Service Bulletin

Subject: Information on Front Door High Retention Retainers Breaking Upon Door Trim Panel Removal

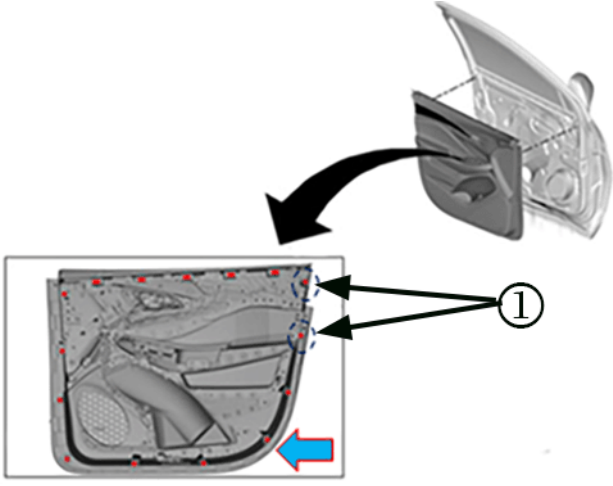
<p>Condition</p>	 <p>Note: As illustrated in the graphic above, most models will have two high retention retainers located at the upper rear of the door trim. Some models may only contain one at that location.</p> <p>Any time a front door trim panel is removed for any repair, the two high retention retainers at the upper rear edge of the door trim (1) will be destroyed during removal.</p>
<p>Cause</p>	<p>The cause of the condition may be that the retention strength exceeds the strength of the clip.</p>

The one or two high retention retainers that are destroyed during removal must be replaced with new high retention retainers to properly reattach the door trim. Always inspect all retainers/clips for damage and replace as necessary. Refer to *Front Side Door Trim Replacement* in SI for any additional clip replacement or sequencing recommendations.
